**RE: KEYYASK GENERATION PROJECT – ALTERATION REQUEST
EXTEND FOOTPRINT OF CENTRAL DAM COFFERDAM AND TAILRACE SUMMER LEVEL
COFFERDAM
ENVIRONMENT ACT LICENCE NO. 3107, CLIENT FILE 5550.00**

Keeyask Generation Project
Central Dam Cofferdam Extension and Tailrace Summer Level Cofferdam Modification
Description of Construction and Potential Environmental Effects

**Powerhouse Tailrace
 Summer Level Cofferdam
 Extension**
 Proposed Design Modification
 March 23, 2016

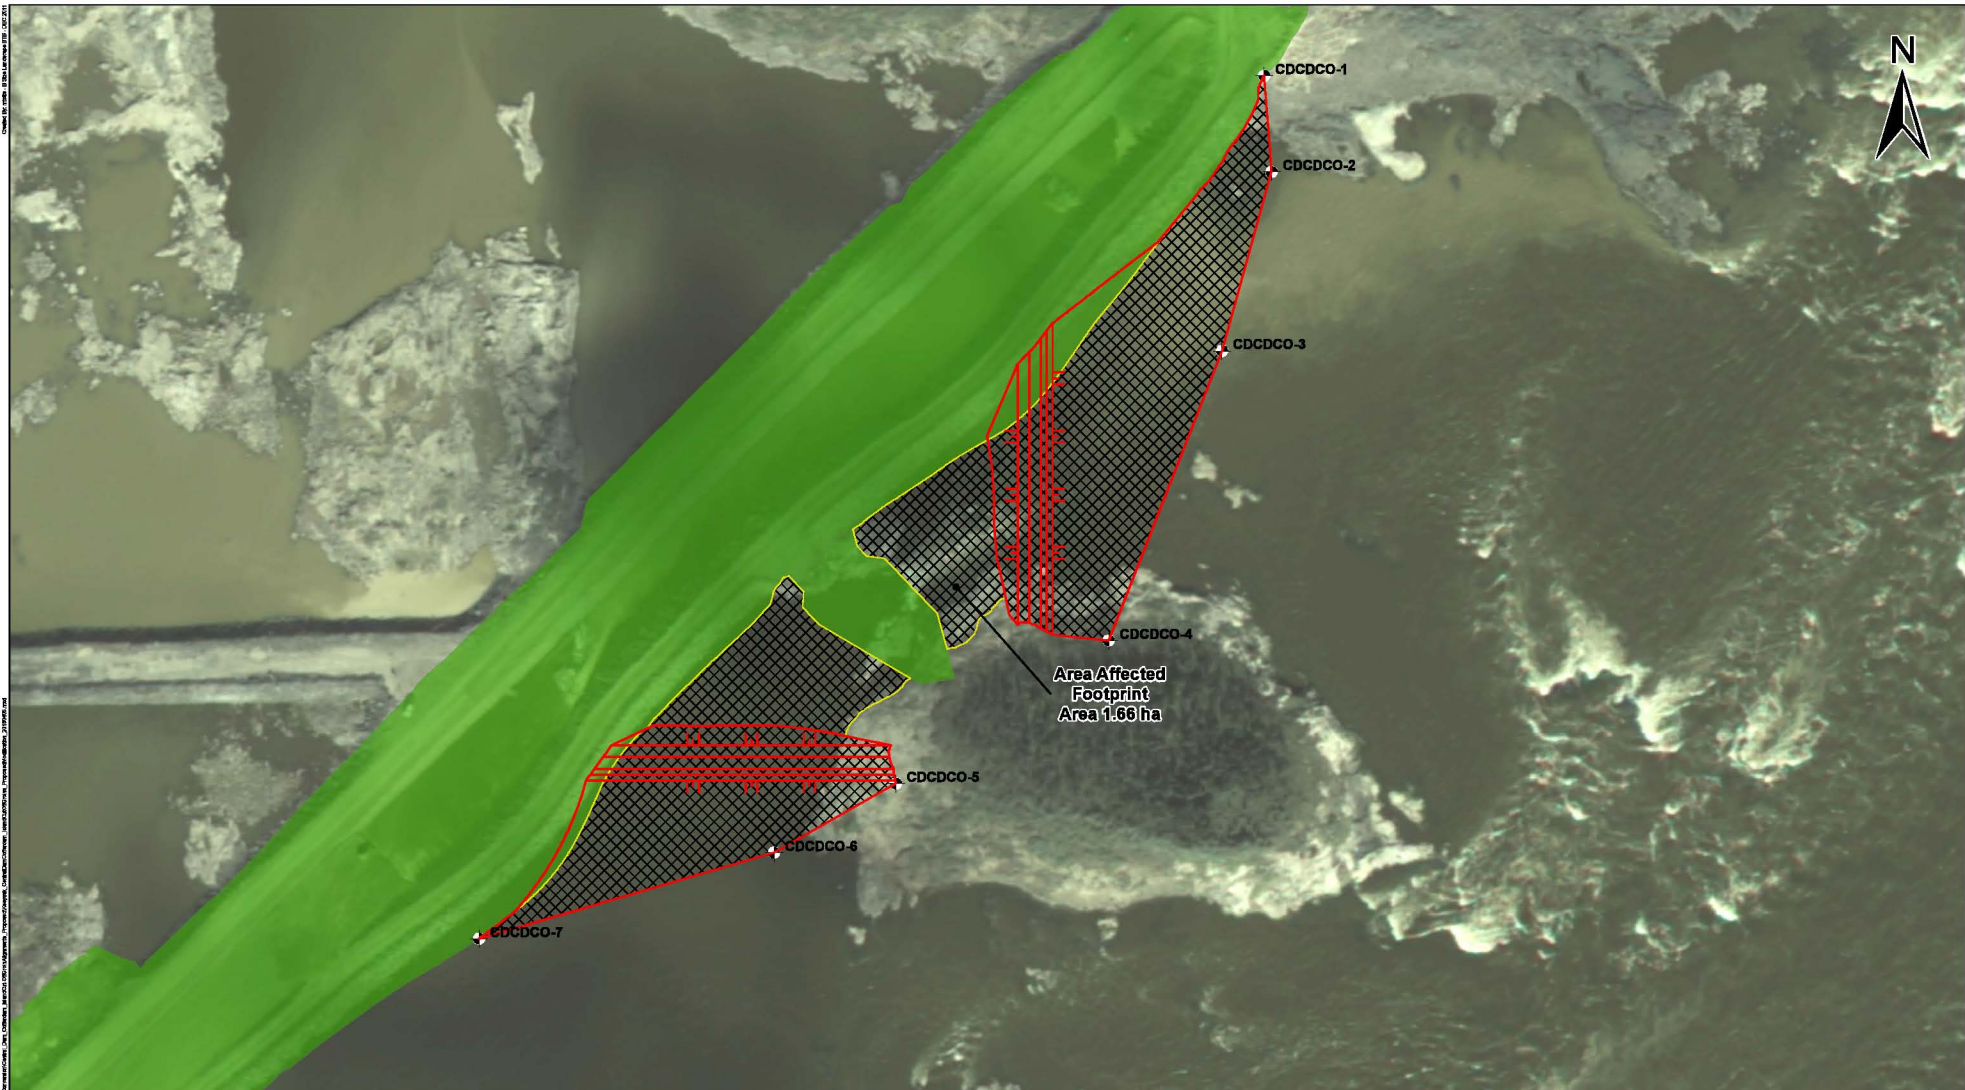
The Tailrace Summer Level Cofferdam as described in the EIS would tie into the Stage I Powerhouse Cofferdam. This would require the outer rock groin and some of the impervious fill from the Stage I Powerhouse Cofferdam to be excavated and removed down to the river bed, which is challenging and extensive, especially since the Powerhouse Cofferdam was raised 7 metres to mitigate against high ice and water levels during the winter of 2014/15. To keep the Stage 1 Powerhouse Cofferdam and winter protection intact, it is proposed that the Tailrace Summer Level Cofferdam be realigned to tie into the Central Dam Cofferdam as shown in the attached Figure.

The additional, temporary in-stream footprint resulting from the re-alignment of the Tailrace Level Cofferdam is approximately 1 hectare and falls within the area identified in the *Fisheries Act* Authorization as permanent alteration of habitat (permanently dewatered area and altered flows). However, this area is beyond the limits identified as the “Planned or Possibly Disturbed Footprint Area” but within the “Altered Water Footprint Area”, shown on Map 5 of the *Keeyask Generation Project Environmental Impact Statement Updates to Project Description Information* (June 2013). This area is within the water lot owned by the Keeyask Hydropower Limited Partnership.
